## Plan Review & Routing Comment Form

Project: Auburn Community Commons - Development Plan  
Revision: Preliminary  
Type: Development Plan  
Logos ID: PROJ-PUBLIC - 2020-00000002  
Due Date: **Jan 15, 2020**

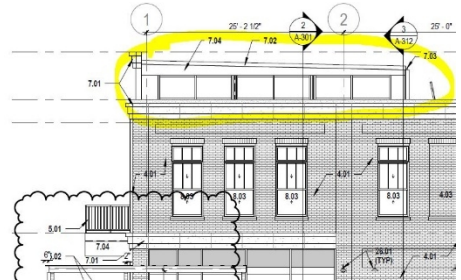
1. Security concerns with opened all day, every day
2. We'd strongly encourage incorporating some sort of storage area within the maintenance space. There always seems to be a need for secured storage areas in downtown.
3. Please consider alternatives to the roof line to allow for natural light and air:
  - Leaving the roof off the open area and designing it to be an open air plaza. It could still have the columns and trusses.
  - Similar to TQS, one portion of the roof being taller than the others with some open air vents (see image)
